Car Stereo Service Bulletin

Model: CDX-7560/7580/5040/7540/7520/5180/
5080/4040/6020/ U8000/R77/R79/ EXCD-40
Subject: MD Board Screws Come Loose

No. 241

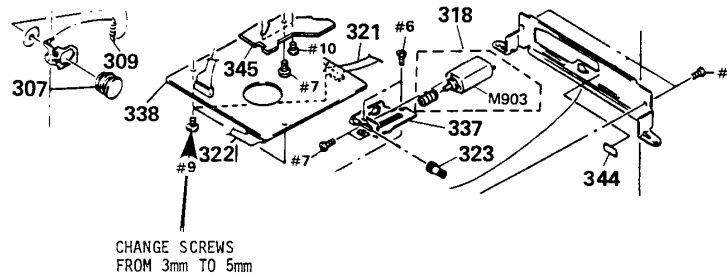
Symptom:
(11) MD Board screws come loose, shorting out parts on the Main Board. The usual customer complaint is "DEAD".

Solution: Perform the following modification:
Change the MD Board screws from 3mm to 5mm.
